ROUTE U.S. 206 At Entrance To Stokes State Forest

CONTRACT NO. 120950525

ADDENDUM NO. 2

**ROUTE 206 AT THE ENTRANCE TO STOKES STATE FOREST
CONTRACT NO. 120950525
SUSSEX COUNTY**

**MITIGATION SITE
 CROSS SECTIONS**

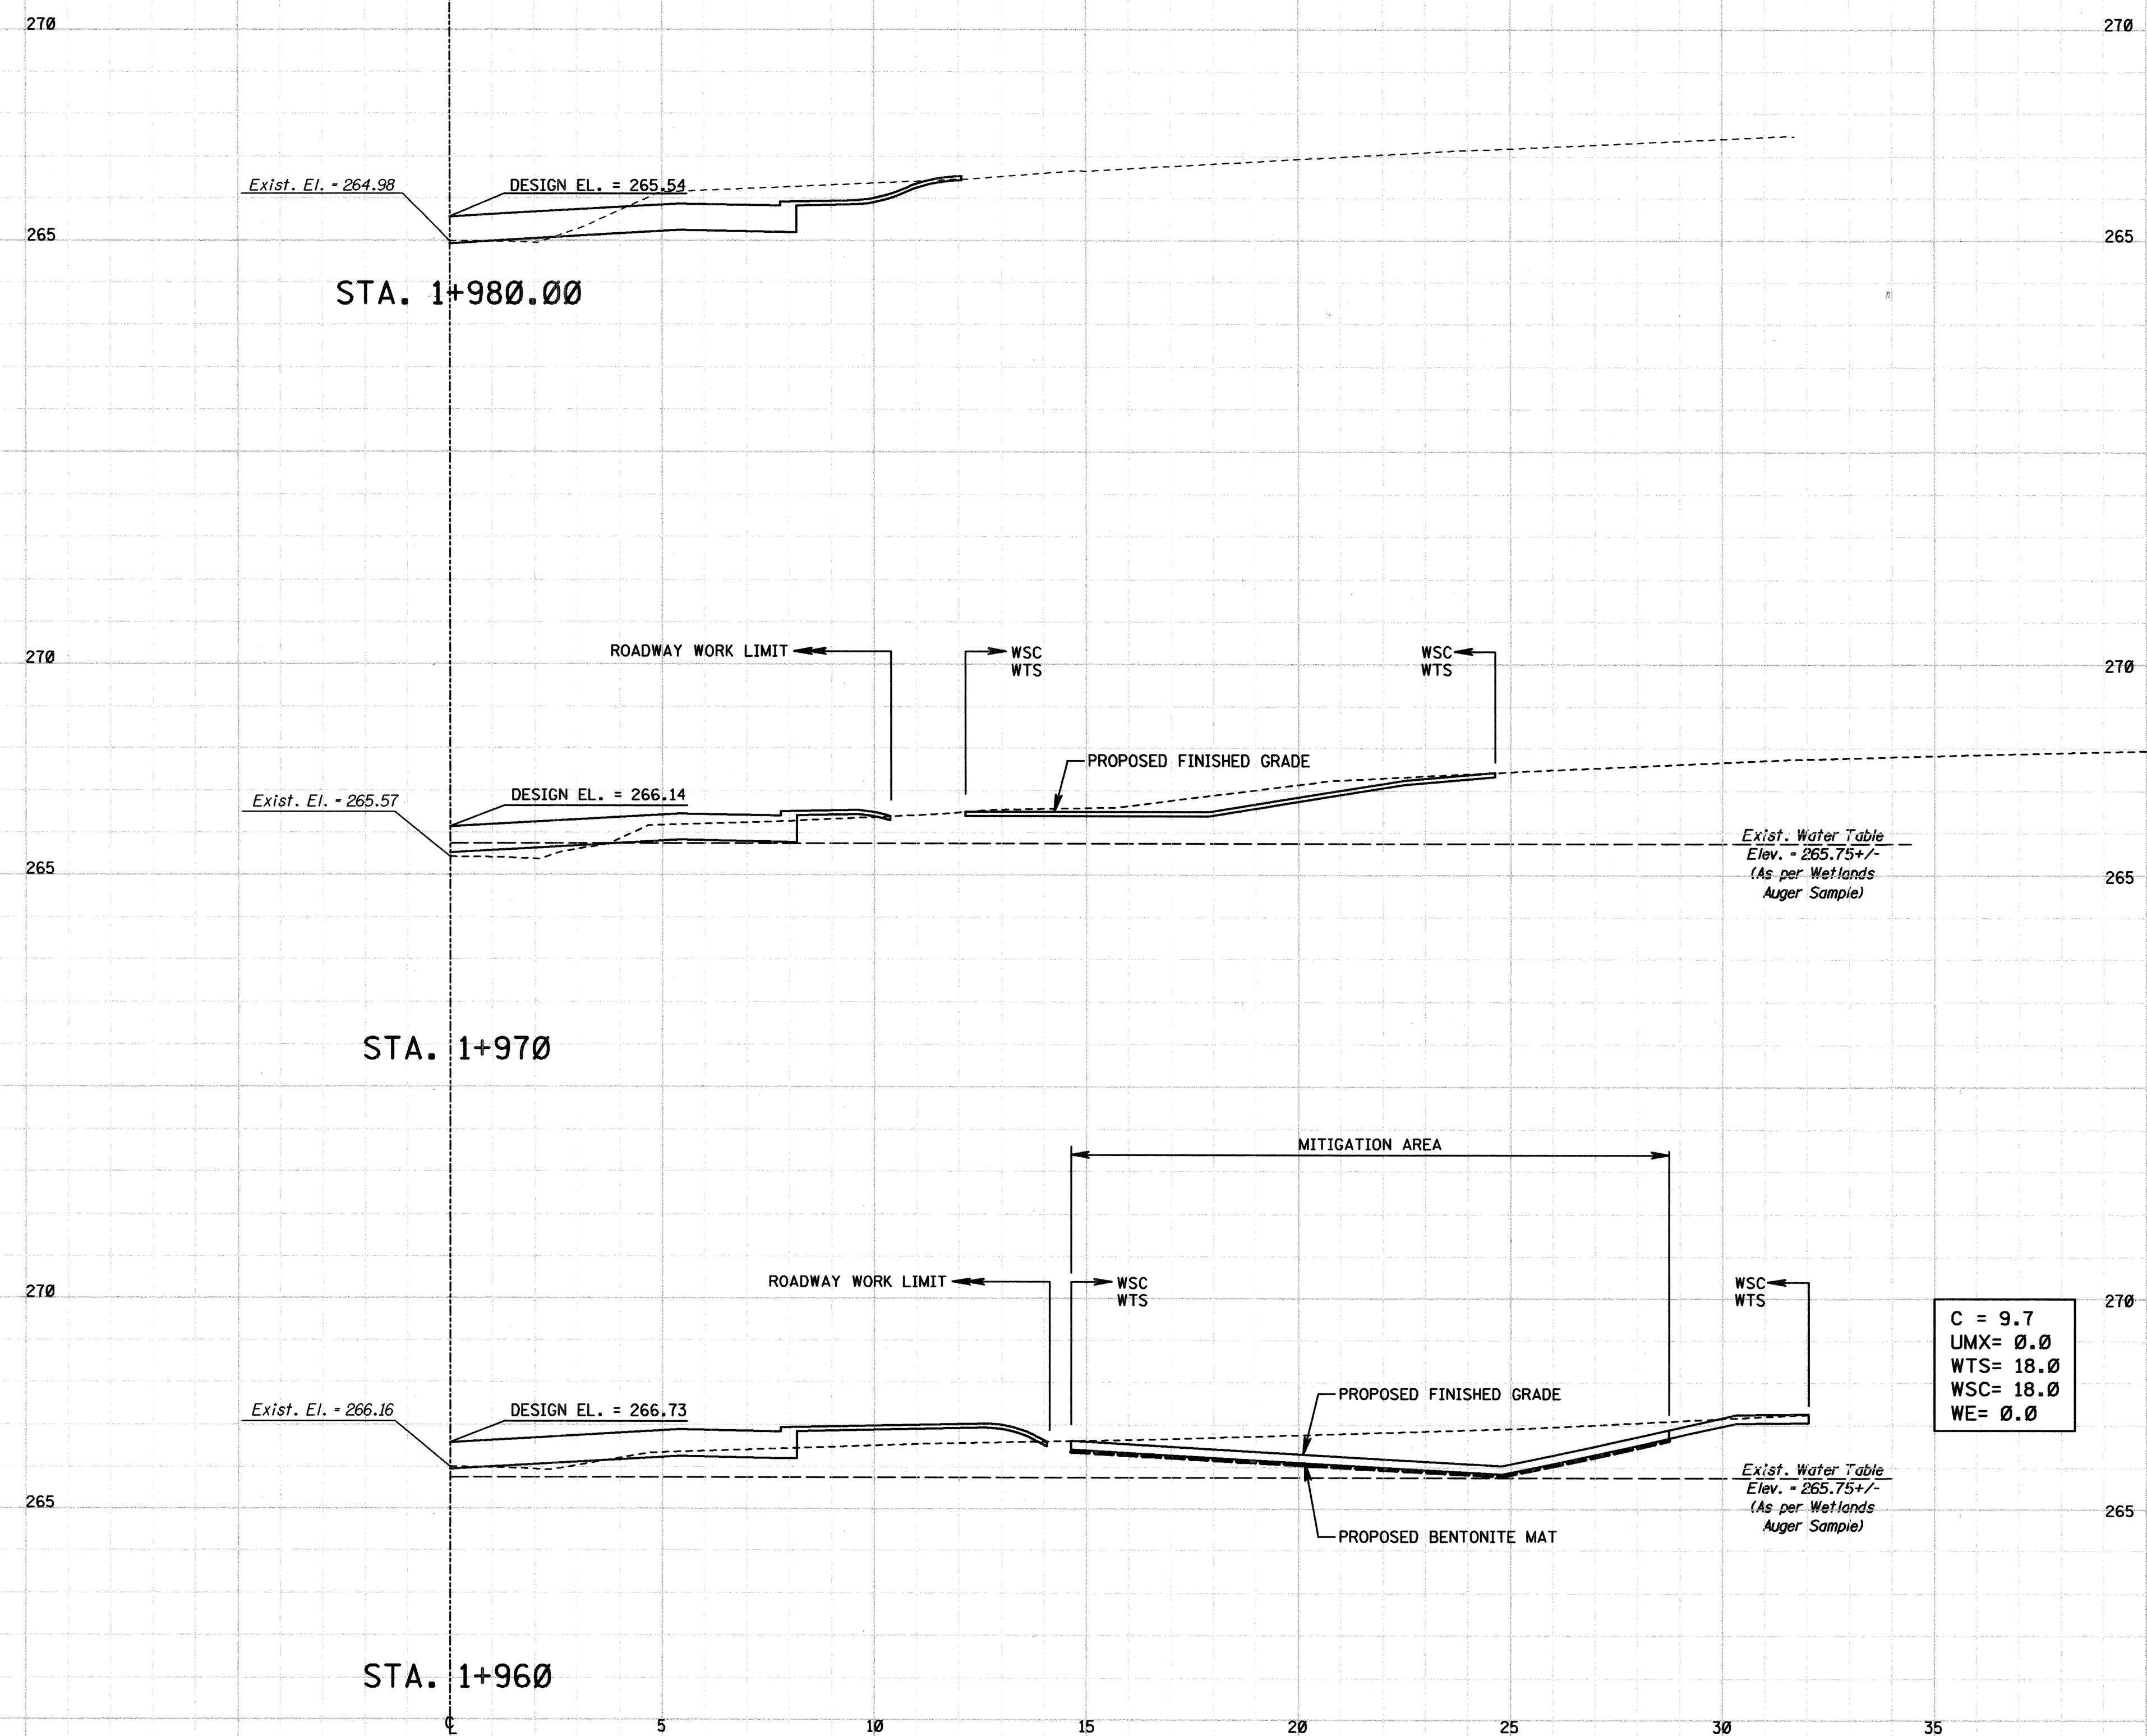
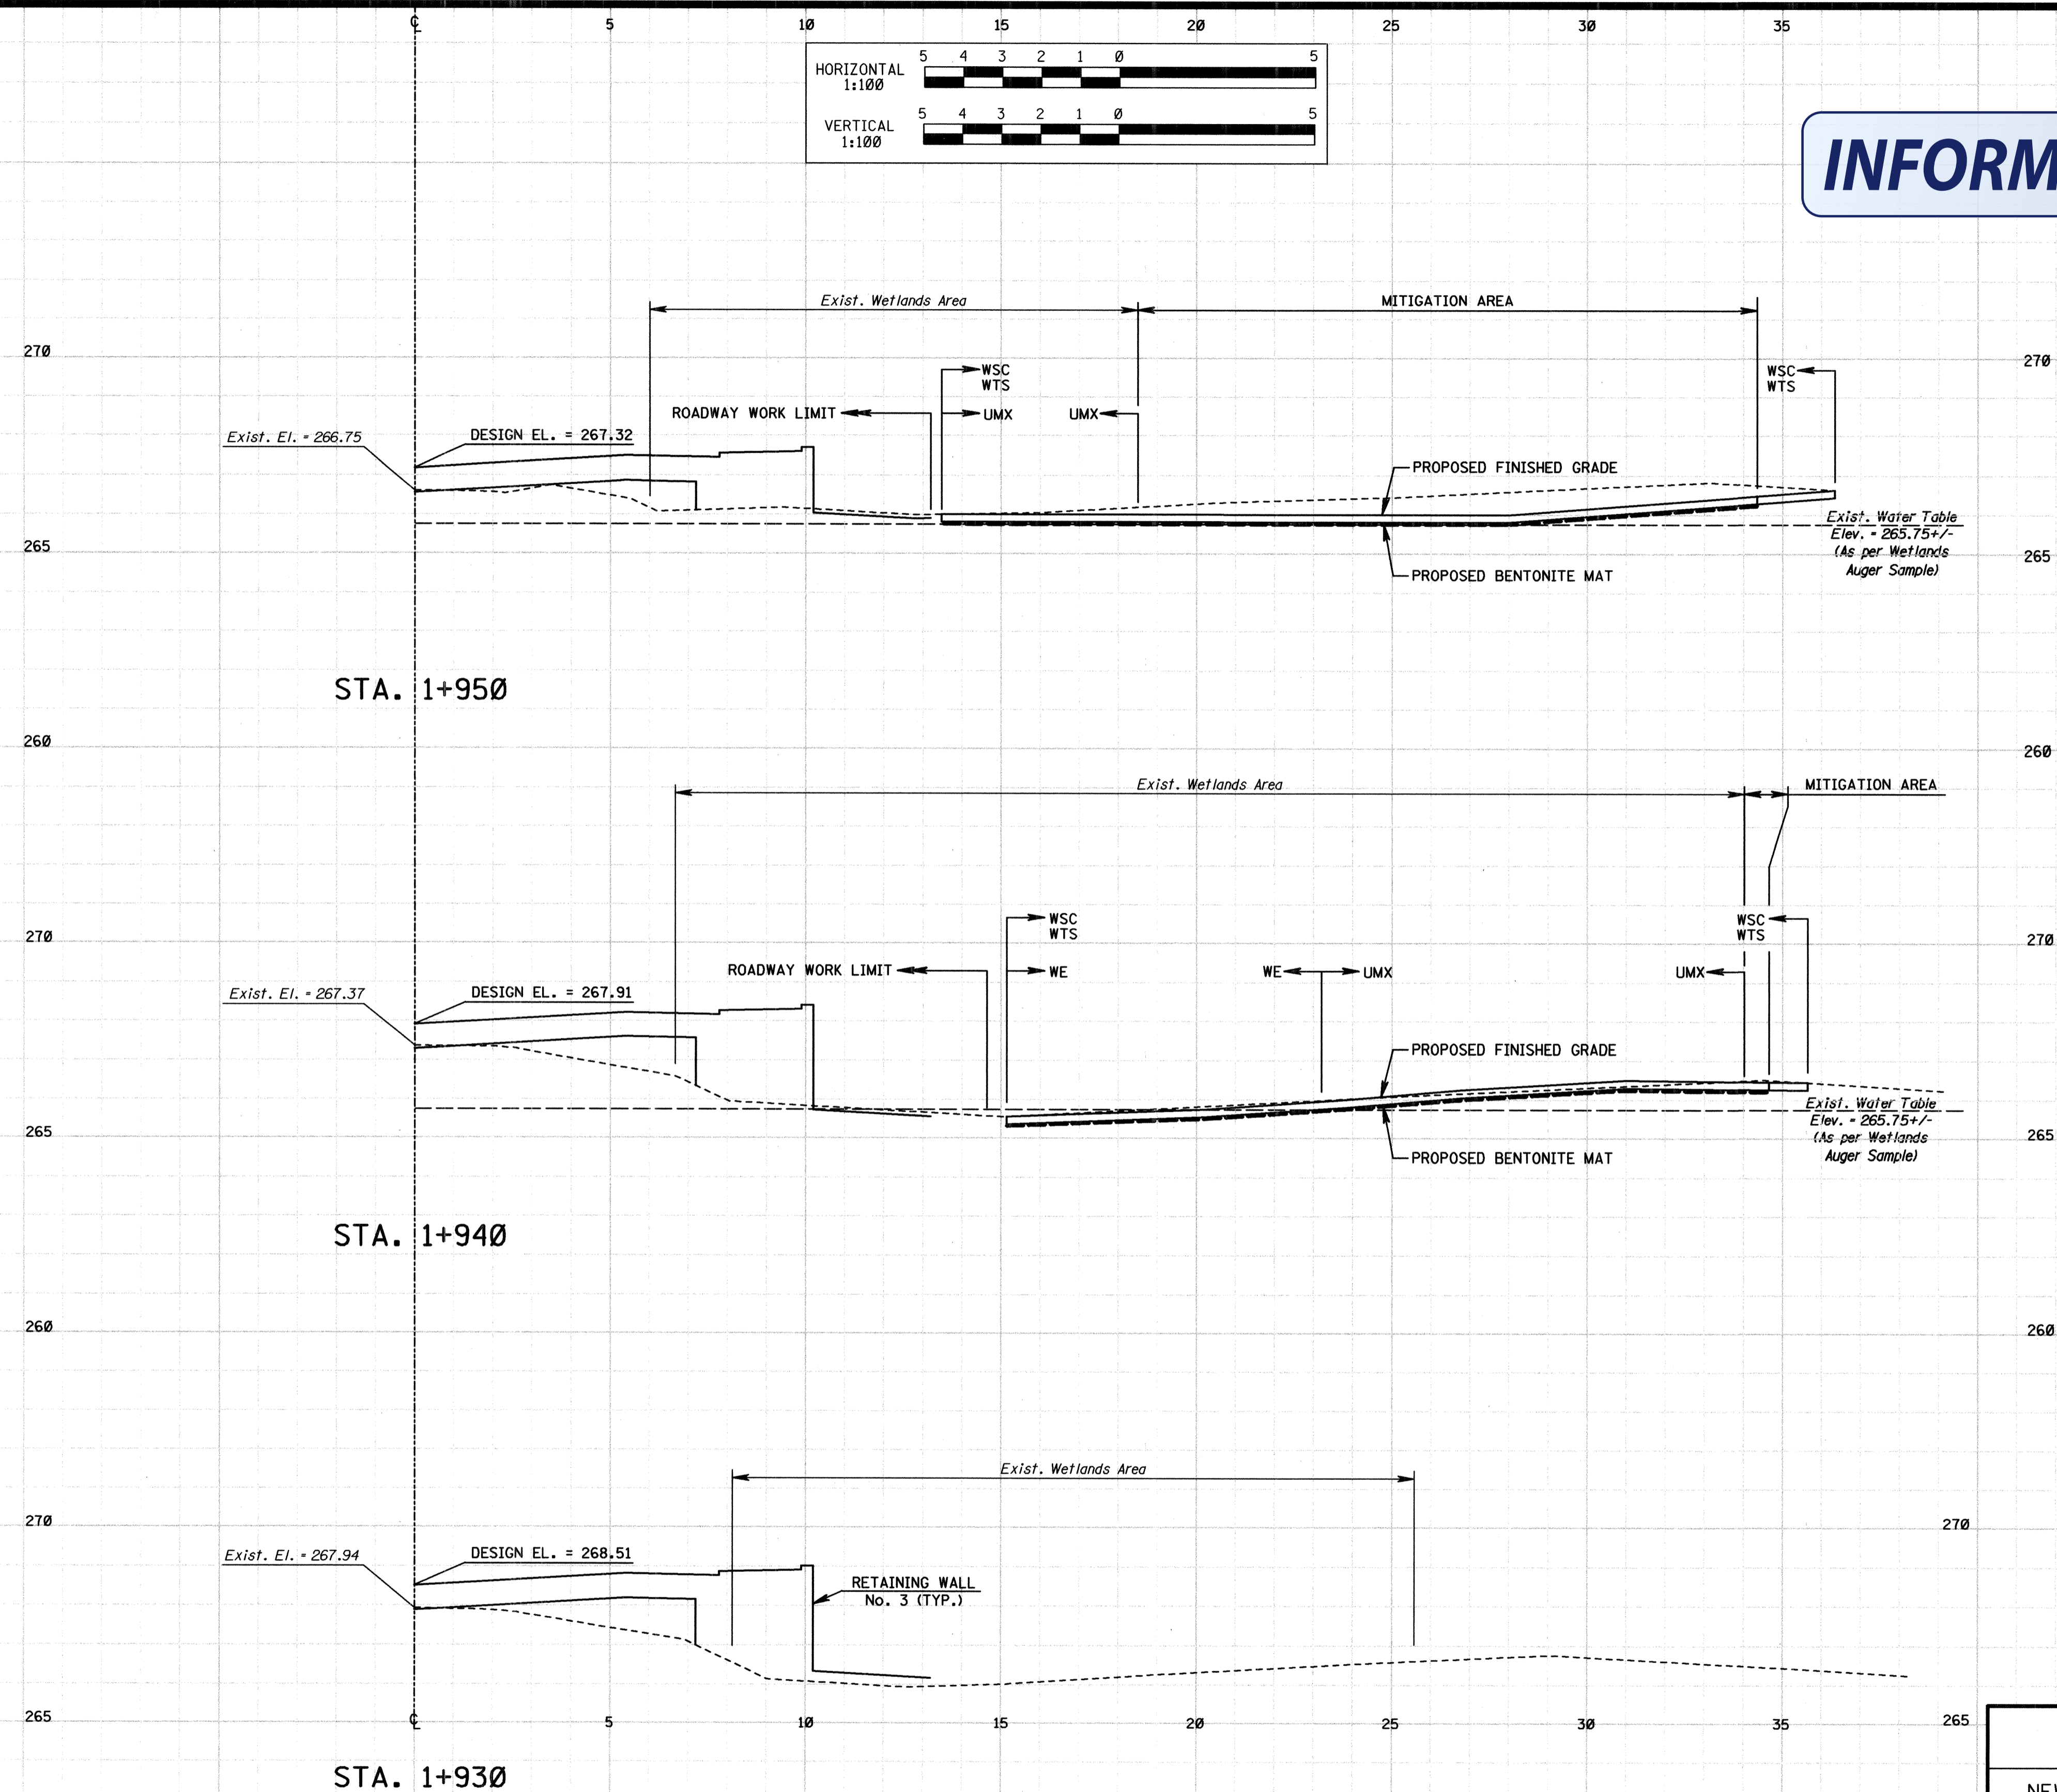
Attachments 1 through 3 inclusive, of Addendum Number 2 are **ADDED** to the plans.
